SUBMITTER No.	668	ISSUE REFERENCE:	9115
SUBMITTER TYPE	NGO	TOR CATEGORY	Transport
NAME	Road Accident Action Group (RAAG)	RELEVANT EIS SECTION	Executive Summary 2.1.2 Transport; Exec Summary 3.1.17.1 Transport Methods and Routes; Exec Summary 3.2.16.1 Transport Methods and Routes; Appendices V5; Appendix 21, Figure 3.6

SUBMITTER No.	356	ISSUE REFERENCE:	9116
SUBMITTER TYPE	Government	TOR CATEGORY	Transport
NAME	DTMR	RELEVANT EIS SECTION	Page 23, Vol 5, Appendix 21 Staffing Operations

Figure 1. Rural Property Access Specifically Designed for Articulated Vehicles

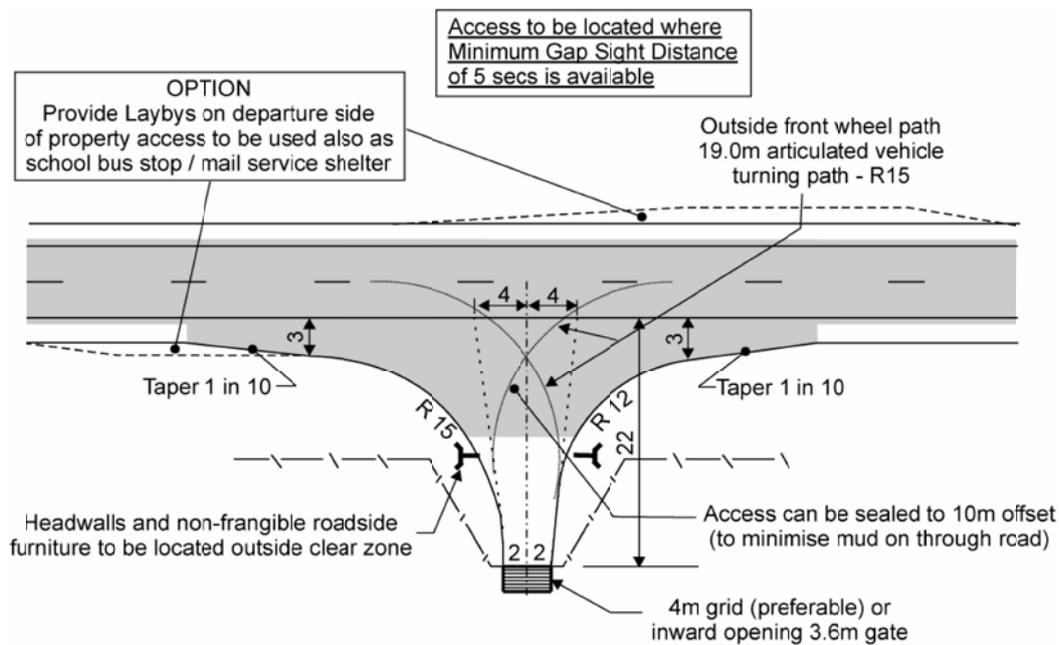
This section indicates that a number of construction camps will require access to the state controlled roads. No detailed information has been provided on the proposed access locations to these camps with the state controlled roads and also the standard of access required.

Information on specific access locations and the proposed form is required along with analysis to support the justification as to the standard of access proposed.

Construction labour resources and associated transport volumes will be calculated during the detailed planning and design phases. It is expected that the majority of transportation will be carried out by local bus services and when the vehicle volumes are determined, discussions with the local authorities will be held to determine standard of roads required and what upgrades are required.

The access design will be based on Figure 1¹.
